Technical Information Bulletin

SUBJECT: GR Bracket K / Magnet Catch **Document No.: 20025**

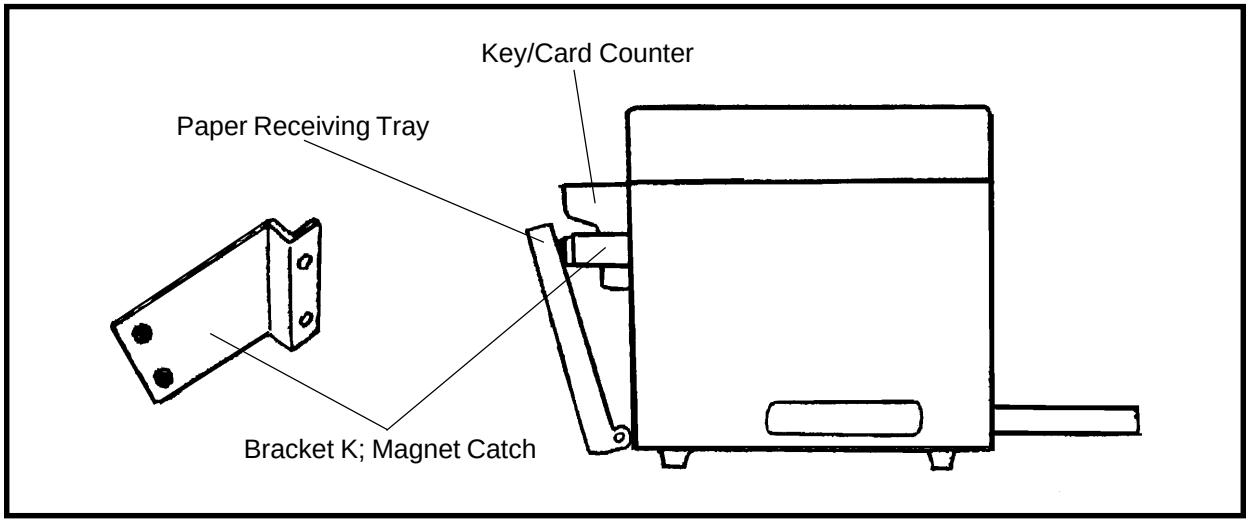
Summary: Users may be prevented from raising the GR Paper Receiving Tray to its upright/ locked position when a Key/Card Counter is installed because the tray contacts the body of the Counter before it can reach its magnetic catch. A new, longer type of Bracket; Magnet Catch is now available to solve this problem.

Procedure: Replace old bracket with new, longer version. The new bracket extends out far enough that the tray is able to connect with its magnetic catch and lock in the upright position.

Old Bracket:	011-13122-109	Bracket; Magnet Catch; P.-Rcv.-T.
New Bracket:	017-13288-000	Bracket K; Magnet Catch; P.-Rcv.-T.
